DEVELOPMENT APPLICATION ASSESSMENT REPORT

Application Number:	DA2024/0978
----------------------------	-------------

Responsible Officer:	Megan Surtees
Land to be developed (Address):	Lot 51 DP 255874, 8 Jinchilla Road TERREY HILLS NSW 2084
Proposed Development:	Construction of a dwelling house
Zoning:	Warringah LEP2011 - Land zoned R2 Low Density Residential
Development Permissible:	Yes
Existing Use Rights:	No
Consent Authority:	Northern Beaches Council
Land and Environment Court Action:	No
Applicant:	Clarendon Homes (NSW) Pty Ltd

Figure 1. Southern elevation envelope breach (extent of breach indicated by red shading).

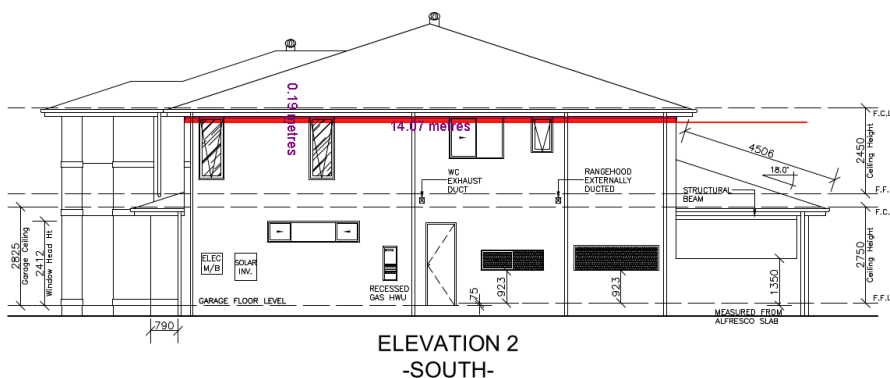
The proposal is compliant with this requirement along the northern elevation. However, as indicated in the figure below, the proposal extends beyond the prescribed side boundary envelope along the southern elevation.

As detailed in the figure above, the extent of non-compliance does not include any portion of the proposed windows along the southern elevation. As such, the non-compliance to this control does not give rise to any unreasonable privacy impacts between the subject site and adjoining properties.

Having regard to the above assessment, it is concluded that the proposed development is consistent with the relevant objectives of WLEP 2011 / WDCP and the objectives specified in s1.3 of the Environmental Planning and Assessment Act, 1979. Accordingly, this assessment finds that the proposal is supported, in this particular circumstance.
